FILE NUMBER: PLN22-006

SUBJECT: Building Site Approval, Design Review, Grading Approval, and Planning Clearance for a new single-family residence, ADU/JADU, livestock shelter, temporary agricultural employee housing, and associated improvements.

SITE LOCATION: Old Calaveras Road, (APN:029-35-007)

RESPONSES TO INCOMPLETE LETTER – 7 ARE PROVIDED IN BLUE

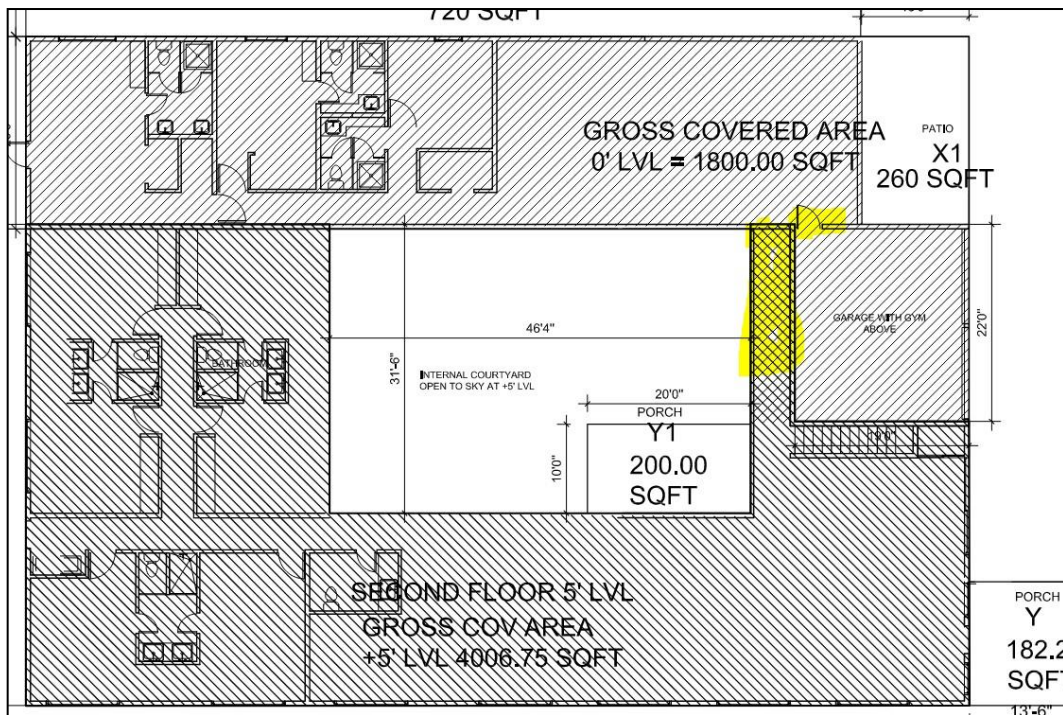
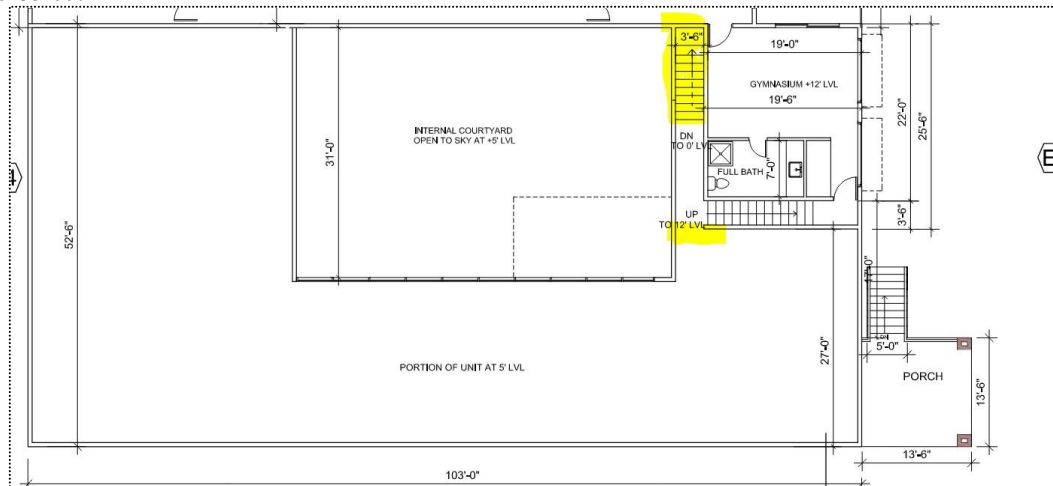
- c. The planting of fruit trees along the driveway accessing the proposed development to minimize visibility from the valley floor, as shown on sheets C1.2, C1.3, and C1.24 of the approved site plan.

Response: The fruit trees that are proposed to screen the portion of the driveway is done as part of the development of orchard in the neighboring land (Gokulam APN 029 34 004) which falls under commercial Agriculture use and is exempted from Landscape plan submission per Santa Clara Ordinance Section 490.1.(c)(2).

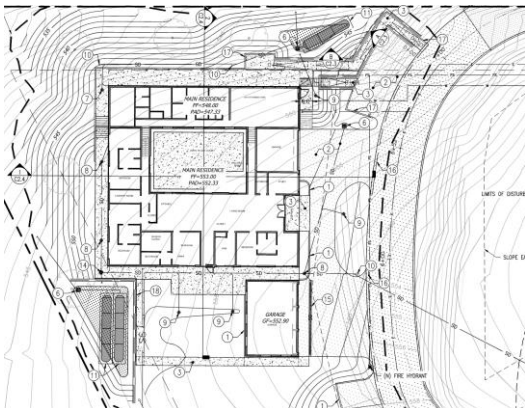
2. For the access road on APN: 029-34-004, a portion of the roadway appears to have been re-aligned; however, this has resulted in larger grading quantities and taller cuts/fills.

20. Please verify that the main residence meets the setback requirements of the zoning ordinance as it appears to be located adjacent to the 40’ wide EVAE, PUE & PAE.

Response: We have an easement with Gokulam LLC (APN 029-34-004), which is considered a right of way and requires a 30ft setback from any structures to meet county regulations. In the application PLN 23-144 for a primary residence on the neighboring Gokulam property, LDE Darrel Wong gave a comment (see below) to maintain 30’ setback from our proposed right of way to the proposed structure. This resulted in the realignment of the road and a change in the height of the road. This adjustment was necessary to comply with county requirements and is a non-discretionary item. Due to the 30ft setback requirement from the property line the house cannot be moved in any direction (north or west) as it is bound by this setback. The only option we had was to realign the roadway to achieve the 30ft setback.

Response: Based on the discussion with Lu Lu and Darrell Wong on 11/12/2023 We have made the following modifications to meet the setback requirements of the zoning ordinance.

- We are proposing to reduce our EVA easement to our neighbor Barsana LLC from the current 40’ to 22’ needed for their commercial livestock shelter access road.
- We are proposing changing the alignment of this 22’ access road and EVA easement as shown in sheet C1.5.
- Then, the Primary residence will be outside the 30’ setback from the 22’ EVA easement as shown in sheet C2.1

- We have relocated the detached garage to the new location to the south of the primary residence as shown so that it is also outside the 30' setback from the 22' EVA easement.
- Please note that less than 6' of the staircase in the Northeast corner of the Primary residence to the parking area will encroach into the 30' setback as allowed by county regulations.
- According to the Santa Clara County municode 4.20.110.3, retaining walls within the setback area are exempt from setback requirements for the ADA ramp. Therefore, we have not removed the retaining walls coming from the road to the main residence patio, as it serves as an ADA ramp. Please refer to the screenshot below of the county ordinance:.
